A Resolution to Approve Changer Order No. 1 to the Iron Removal Facility Project.

Bulletin 1 – City of Grand Ledge Iron Removal Plant, Description, and Impact

CONTRACT FOR:	City of Grand Ledge Iron Removal Plant
OWNER:	City of Grand Ledge 310 Greenwood Street Grand Ledge, MI 48837
CONTRACTOR:	RK Davis, Inc. 4457 40th Street, SE Kentwood, MI 49512
ENGINEER:	Fishbeck 1515 Arboretum Drive, SE Grand Rapids, MI 49546
DRAWING REVISION NO.:	N/A
ISSUED HEREWITH:	
SPECIFICATION SECTIONS:	None
SKETCHES:	None
SHEETS:	None
DISTRIBUTION:	Kurt Ristow – City of Grand Ledge Peter Elzinga – RK Davis, Inc. Rob Kaliniak – RK Davis, Inc. John Willemin, PE – Fishbeck

PROJECT NO. 210262
SHEET NO. S101
DRAWN BY: TJB
DESIGNER: TJB
REVIEWER: CDB
MANAGER: CDB
HARD COPY IS REQUIRED FOR CONSTRUCTION. THIS DRAWING SHALL BE USED ONLY WHEN INDICATED AND SHALL BE SUBJECT TO THE TERMS AND CONDITIONS OF THE CONTRACT. NOT BE ACCURATE FOR ANY OTHER PINK.

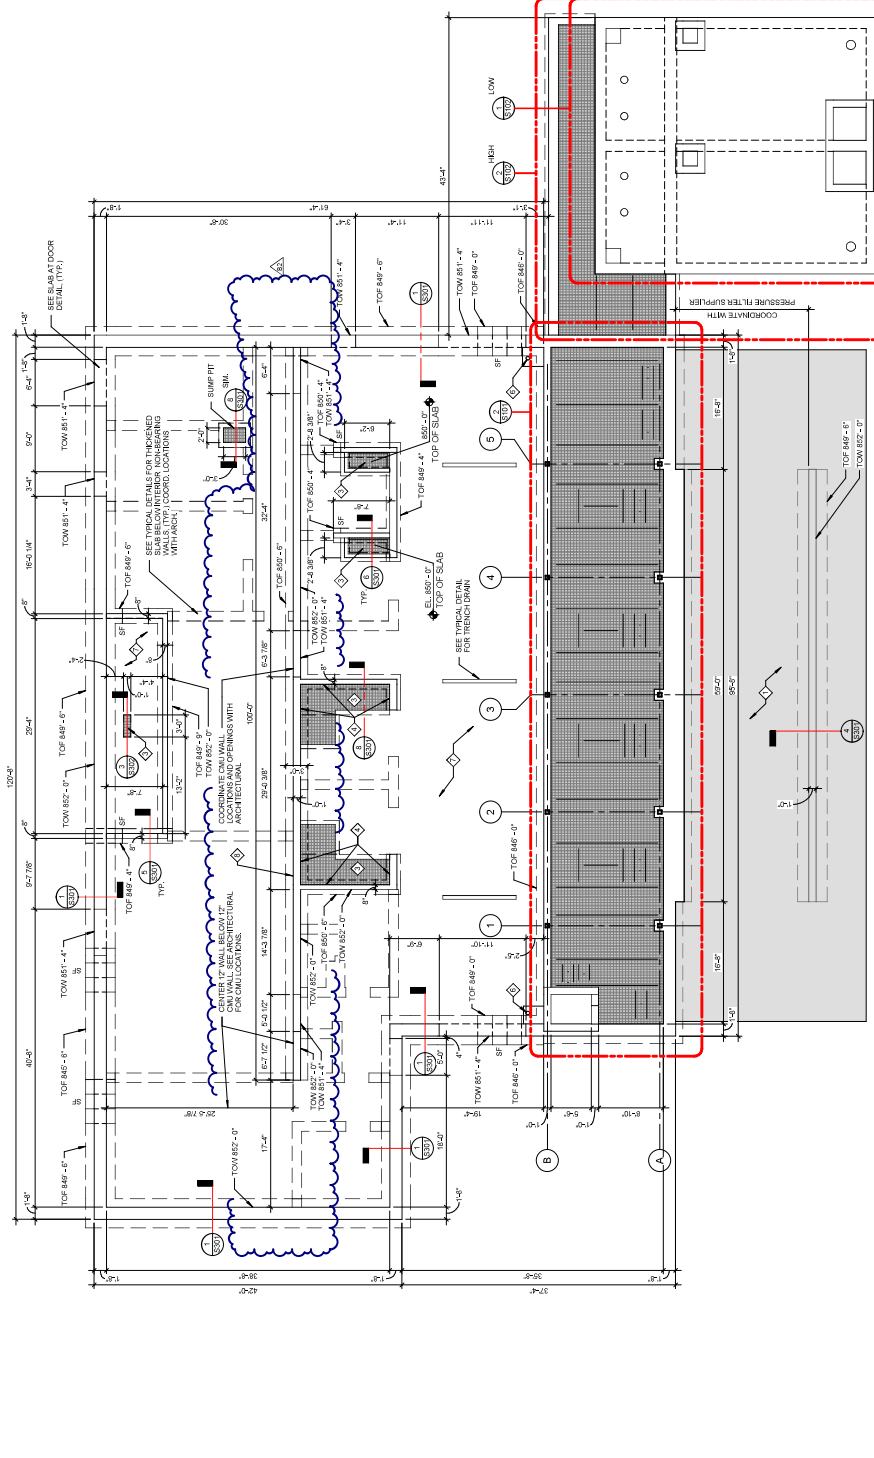
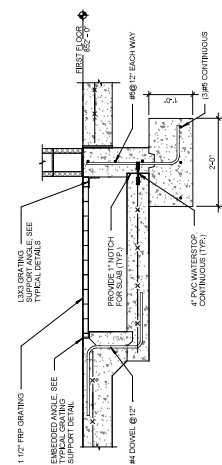
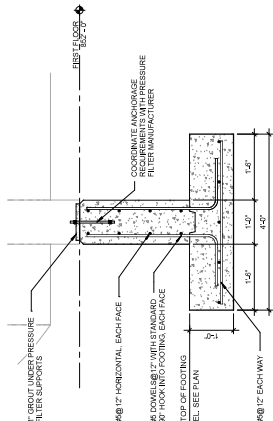
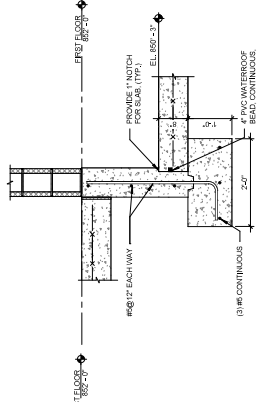
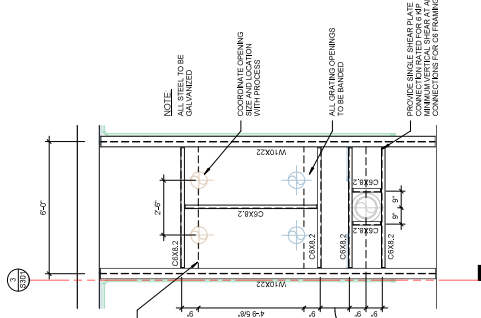
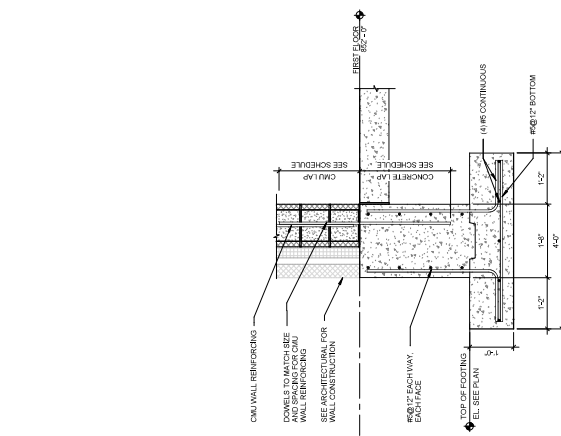
Sheet: S101 – Foundation Plan (reissued)
A. Modify turn down slab to be wall foundation as noted.

Sheet: S101 – Foundation Plan (reissued)
S301 – Sections and Details (reissued)
S303 – Sections and Details (reissued)
Section: 07 13 00 – Waterproofing (issued)
A. Clarification added to drawings showing extent of previously noted waterproofing and protection board.
B. Waterproofing specification issued in response to RFI 3.

Sheet: S003 – Typical Details (reissued)
S101 – Foundation Plan (reissued)
A. Reduce size of baseplates as noted.

PROJECT NO. 210262
 SHEET NO. M701
 TITLE: Iron Removal Plant
 DATE: 05/21/2023

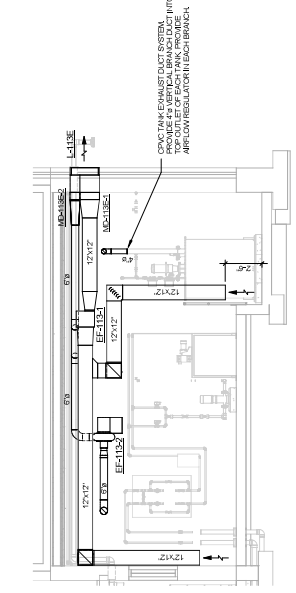
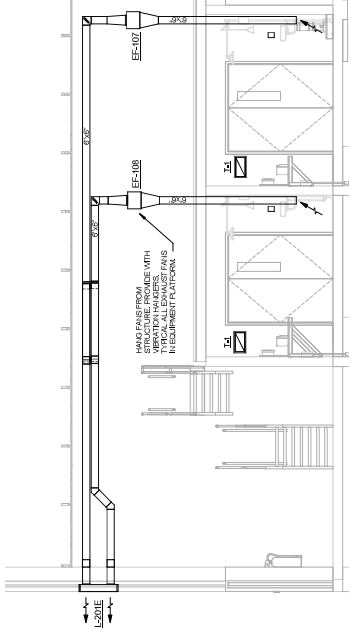
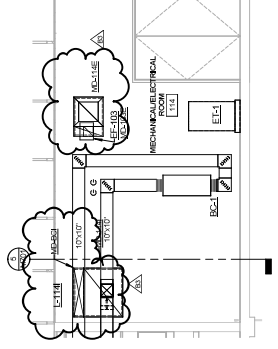
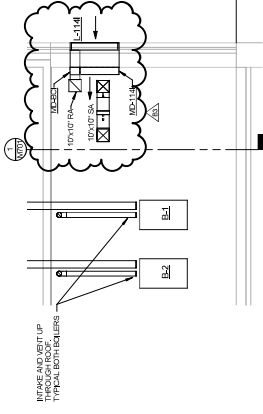
Sheet: M701 – Sections (reissued)
M901 – Schedules (reissued)

Sheet: M501 – First Floor Mechanical Sheet Metal Plan (reissued)
M701 – Sections (reissued)
